NP-11-0014  
May 13, 2011

Subject: Exelon Nuclear Texas Holdings, LLC  
Victoria County Station Early Site Permit Application  
Response to Request for Additional Information Letter No. 06  
NRC Docket No. 52-042

**RAI 02.04.04-2:****Question:**

**RAI 13.03-20:****Question:**

Figure 1. Time History of Water Level at the Southwestern Corner of the Security Wall for Manning's  $n$  Sensitivity Test (The water level for  $n=0.03$  is the same as SSAR Figure 2.4.4-21, and the starting time is arbitrarily selected.)

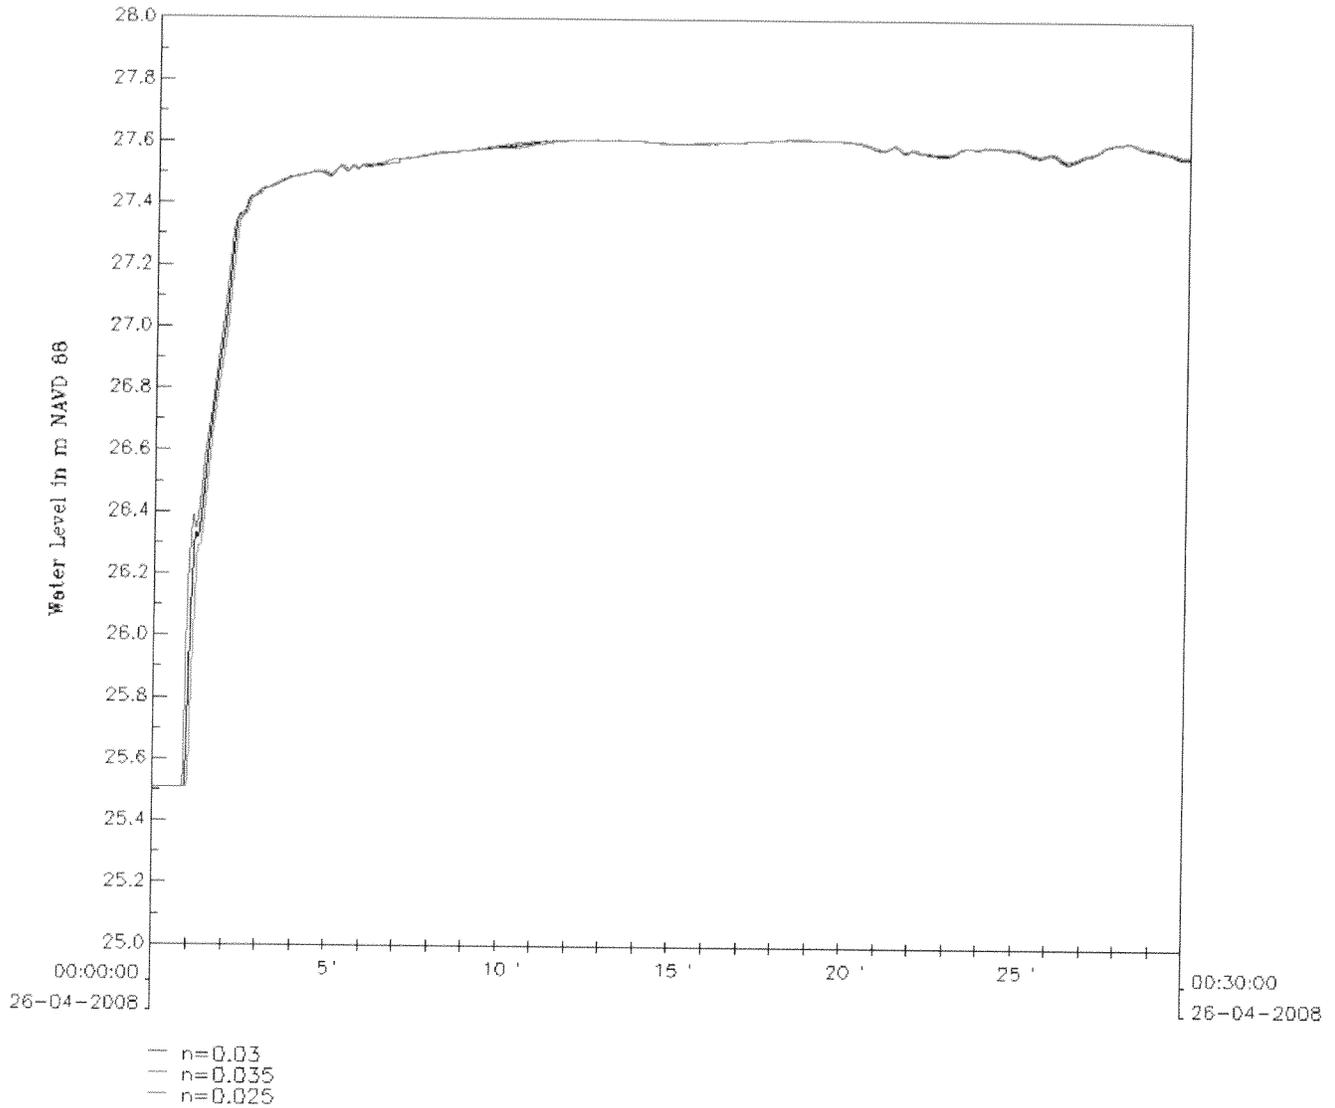
The staff has reviewed the application in accordance with the requirements of “Factors to be considered when evaluating sites” 10 CFR 100.20(c), and “Contents of application: technical information in the final safety analysis report” 10 CFR 52.79(a). The application does not provide detailed information discussing the cooling basin pool elevation selected for analysis and does not provide the background on the selection of the Manning’s  $n$ . Please provide additional information showing the selection of the cooling basin initial water surface elevation and the selection of Manning’s  $n$  in the vicinity of the breach, where applicable, considering that there are more conservative assumptions available.

According to SSAR Subsection 2.4.8, the CB has a 31.5-foot wide (9.6 meters) ogee emergency spillway with four slide gates, each 6 feet (1.83 meters) wide and 7 feet (2.13 meters) high. The gates rest on top of the spillway that has a crest elevation of 87 feet (26.5 meters) NAVD 88, and the top of the gates when closed is at elevation 94 feet (28.65 meters) NAVD 88. The spillway gates are designed to open and release flood water when 1 foot (0.31 meters) or more of precipitation occurs. For the purpose of the CB breach analysis, the spillway gates are assumed closed (or out of service) when considering the coincidental event of the one-half PMP, thus resulting in a higher (conservative) initial water level in the CB.

With the normal maximum operating water level of the CB at 91.5 feet (27.9 meters) NAVD 88, the maximum water level in the CB from routing the one-half PMP; i.e., the initial CB water level, is 93.9 feet (28.62 meters). This value is slightly higher than the direct summation of the normal maximum operating water level of the CB and the one-half PMP falling on the CB; i.e., 93.8 feet (28.59 meters). The difference is due to the runoff contribution from the embankments and dikes to the CB water body.

Figure A-1

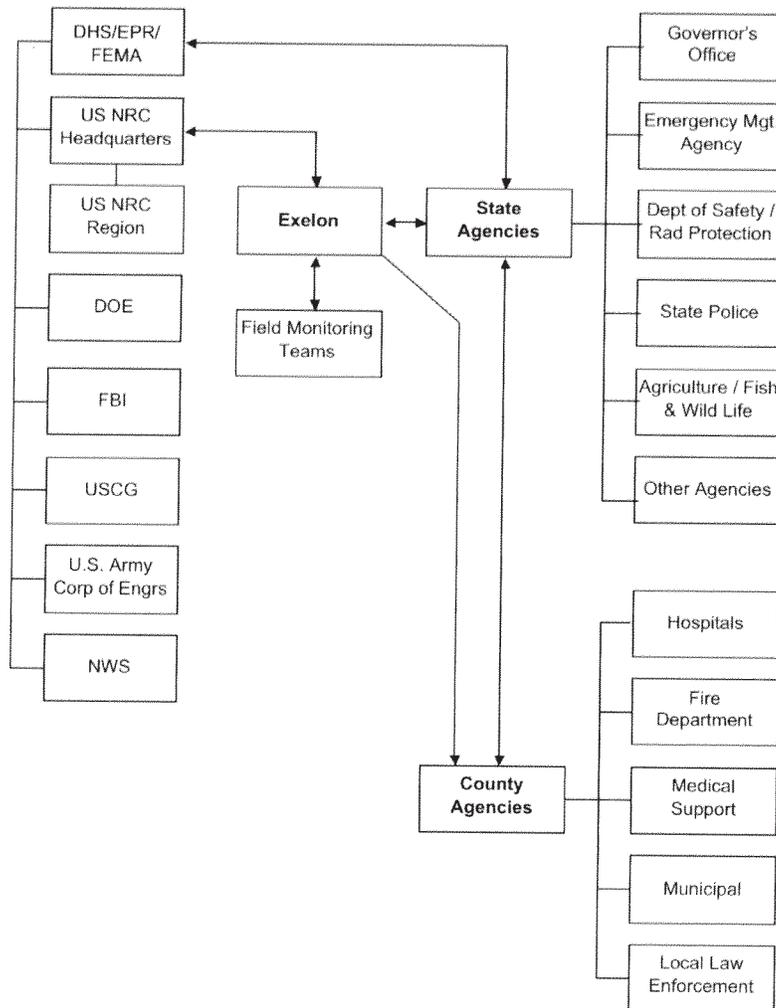
- RAI A-7. Include the Department of Homeland Security (DHS) in Figure A-2 of the Exelon Nuclear Standardized Radiological Emergency Plan, "Agency Response Organization Interrelationships" or justify why this is not necessary.
- RAI A-8. Section A.3 of the Exelon Nuclear Standardized Radiological Emergency Plan, "Agreements in Planning Effort," explains that written agreements have been developed that establish the concept of operations between the applicant and other support organizations having an emergency response role. Provide copies of the Letters of Agreement established with local support agencies in the Emergency Plan or Annex, or describe where these documents are maintained.

- RAI A-7      Figure A-1 in the VCS Annex has been revised to replace FEMA with DHS/EPR/FEMA.
- RAI A-8      The Letters of Agreement obtained during the development of this Annex are provided in Attachment 18.
- Victoria Fire and Rescue – fire protection and ambulance response.
  - The Victoria County Sheriff's Office – law enforcement.
  - Citizens Medical Center – medical services.
  - DeTar Hospital Navarro – back-up medical services
  - Victoria County – EOF and JIC location
  - Crossroads Chapter Red Cross – congregate care facilities.

Figure 4-1: Victoria County Station PAR Determination Flowchart

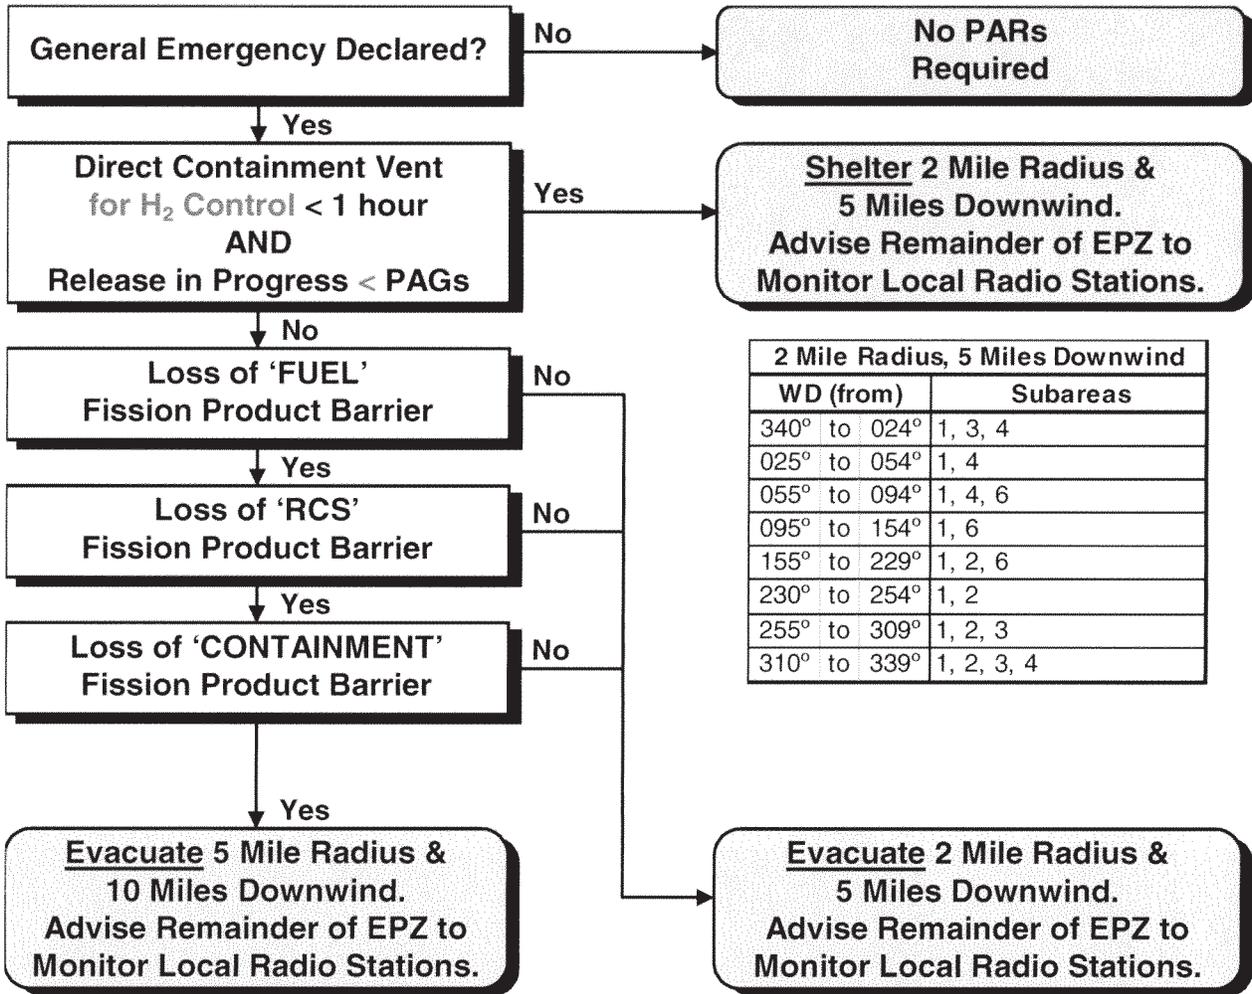
- RAI J-5. Figure 4-1, "Victoria County Station PAR Determination Flowchart," of the Victoria Annex provides the steps considered in making the PAR determination. Explain in the Annex how the Evacuation Time Estimate is used in conjunction with PARS to develop the evacuation plan or justify why this is not necessary.

RAI J-5: NUREG-0654, Supplement 3 provides guidance on the issuing of Protective Action Recommendations (PARs) for the general public. Unless determined by Exelon during a declared General Emergency that the release of radioactive material is a "puff release" the ETE will not be considered when making protective action recommendations. The Plant operators may not have information regarding the environmental concerns regarding the off-site areas surrounding the site. The county or state officials will take into consideration the ETE for the current environmental conditions and make a decision to utilize the VCS PARs or to modify them based on additional information that they have concerning the evacuation routes.
